Application for "Other Business" Cobb County, Georgia

State specifically the need or reason(s) for Other Business: Request modification to Z-17 of 2011 to delete the commercial indoor recreation usage with outside tennis courts, corresponding with Town Center Design Guidelines, and allow for office and warehouse use, corresponding to LI Zoning District Guidelines.

RAY L. DIODATI (Diodati Acquisitions, LLC, owner) requesting Rezoning from LI with Stipulations to GC for the purpose of Indoor Recreation in Land Lot 173 of the 20th District. Located on the southeast side of Cobb Place Boulevard, southeast of Vaughn Road.

PETITION NO. Z-017

Proposed

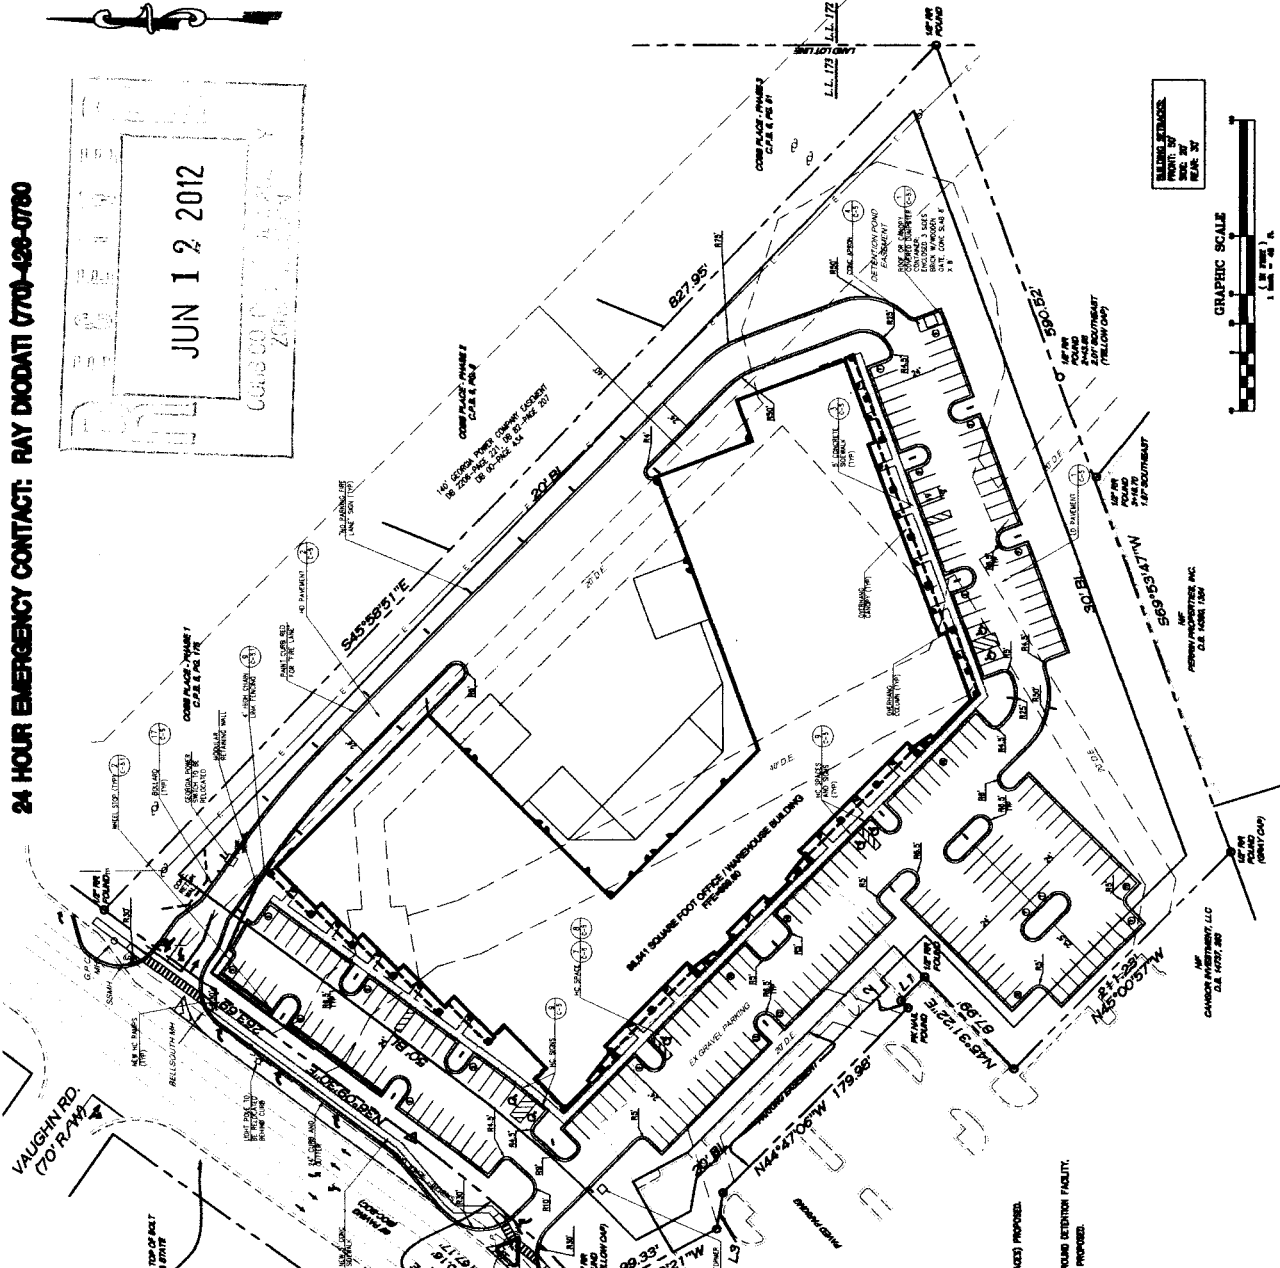
- Provide comprehensive hydrology/stormwater controls to include development of out parcels.
- Submit all proposed site improvements to Plan Review.
- Any spring activity uncovered must be addressed by a qualified geotechnical engineer (PE).
- Structural fill _____ must be placed under the direction of a qualified registered Georgia geotechnical engineer (PE).
- Existing facility.
- Project must comply with the Water Quality requirements of the CWA-NPDES-NPS Permit and County Water Quality Ordinance.
- Water Quality/Quantity contributions of the existing lake/pond on site must be continued as baseline conditions into proposed project.
- Calculate and provide % impervious of project site.
- Revisit design; reduce pavement area to reduce runoff and pollution.

- No Stormwater controls shown _____
- Copy of survey is not current – Additional comments may be forthcoming when current site conditions are exposed.
- No site improvements showing on exhibit.

1. The site is encumbered by an existing detention pond as well as previously recorded multiple drainage easements. The current above-ground pond will be replaced by an underground facility. The new detention facility must account for the existing development on Tract 1, the proposed tennis center development on Tract 2 as well provide conveyance capacity for the upstream runoff through the site.
2. Any changes to the existing drainage easements must be reflected on a re-recorded plat.

Recommend installing sidewalk along the road frontage.

Recommend applicant relocate the proposed driveway and coordinate with Cobb County DOT on the location at the time of plan review.

Recommend deceleration lane on Cobb Place Boulevard for proposed access.
